ADDRESS : 227 PEANUT LN SUBDIV:
CONTRACTOR : H & H ONSITE HOMES LLC PHONE : (910) 486-4864
OWNER : BERTRAN CHRISTINA AND RICHMEN PHONE :
PARCEL : 09-9544- - -0009- -10-
APPL NUMBER: 14-50034763 CP NEW RESIDENTIAL (SFD)
DIRECTIONS : T/S: 10/17/2014 10:25 AM DJOHNSON --
27W TO CAMERON THEN TURN ON BRIGGS RD
TO PEANUT LN

PERMIT: CPSF 00 CP * SFD

Re: J0714-3561

~~H&H Onsite Lot 6 Briggs Farm~~ Cumberland

| J0714-3581 | B2 | PIGGYBACK BASE | 5 | 1 | | |

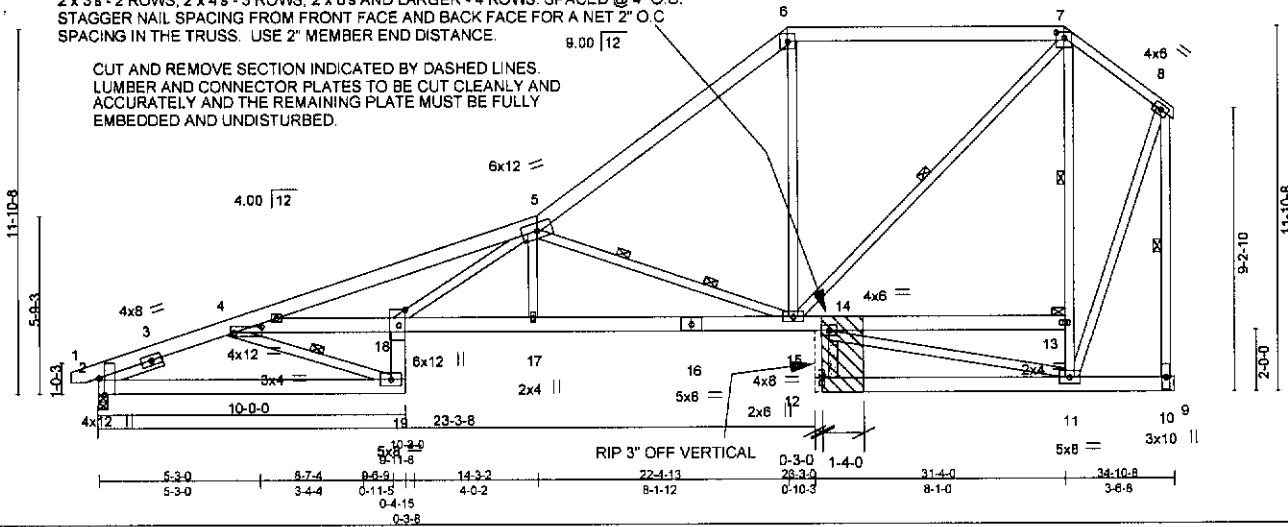
| TYP/SQ | REQUESTED COMPLETED | INSP RESULT | DESCRIPTION RESULTS/COMMENTS |
|---------|---------------------|-------------|--|
| R425 02 | 3/13/15 3/13/15 | TSG AE | FOUR TRADE ROUGH IN TIME: 17:00 VRU #: 002633667 1-All A02 TRUSS HAVE BEEN CUT DAMAGING THE CONNECTIOR PLATE 2-INTERIOR LOAD BEARING WALLS REQUIRE A MINIMUM OF A POWDER FIRED ATTACHEMENT. CUT NAILS NOT ALLOWED OK TO INSULATE OK TO SIDE |

ATTACH 1/2" PLYWOOD OR OSB GUSSET (15/32" APA RATED SHEATHING 32/16 EXP 1) TO EACH SIDE OF TRUSS WITH (0.131" x 2.5") NAILS PER THE FOLLOWING SCHEDULE:
 2 x 3's - 2 ROWS, 2 x 4's - 3 ROWS, 2 x 6's AND LARGER - 4 ROWS: SPACED @ 4" O.C.
 STAGGER NAIL SPACING FROM FRONT FACE AND BACK FACE FOR A NET 2" O.C SPACING IN THE TRUSS. USE 2" MEMBER END DISTANCE.
